RE: COMMUNICATION

ITEM #22 - COMMITTEE OF THE WHOLE - MARCH 3, 2015

OFFICIAL PLAN AMENDMENT FILE OP.12.006 ZONING BY-LAW AMENDMENT FILE Z.12.015

SITE DEVELOPMENT FILE DA.12.037

Revised Attachment No.3 Location: Part of Lot 9,

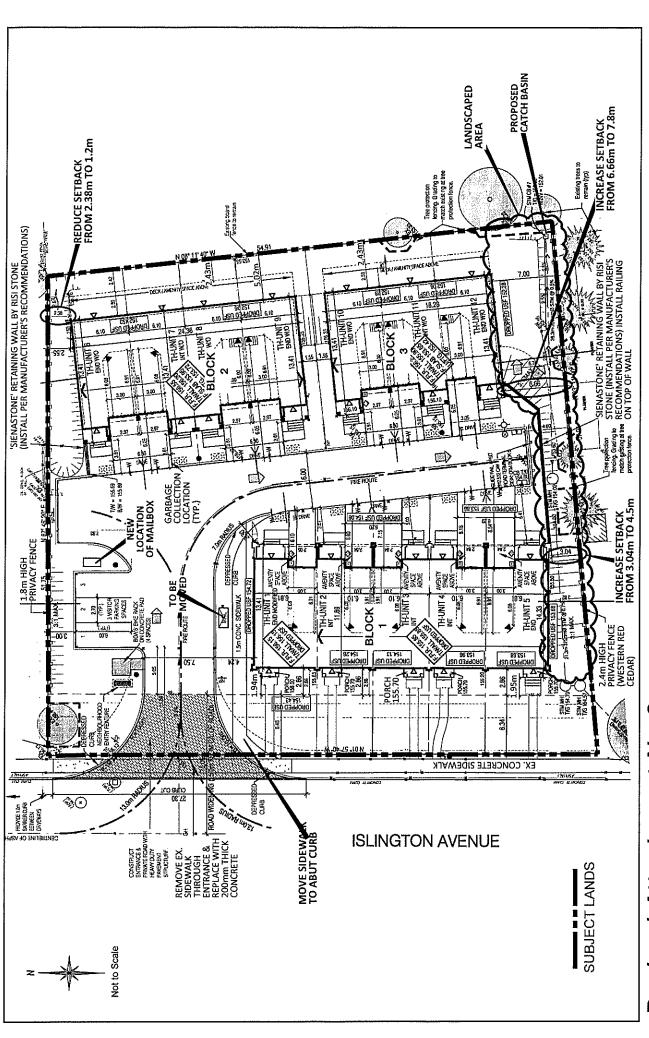
- 1. THAT Attachment #3 of the Report of the Commissioner of Planning, Director of Development Planning, and Manager of Development Planning dated March 3, 2015, with respect to Official Plan Amendment File OP.12.006, Zoning By-law Amendment File Z.12.015 and Site Development File DA.12.037 (2165496 Ontario Inc.) be deleted, and replaced with the revised site plan shown as Revised Attachment #3 attached hereto to this Communication.

Should the Committee concur, Attachment #3 in the staff report, can be deleted and replaced with the Revised Attachment #3, attached hereto in this Communication, and Table 1: Proposed Zoning Exceptions and Table 2: Recommended Zoning Exceptions can be amended in the manner identified in this Communication.
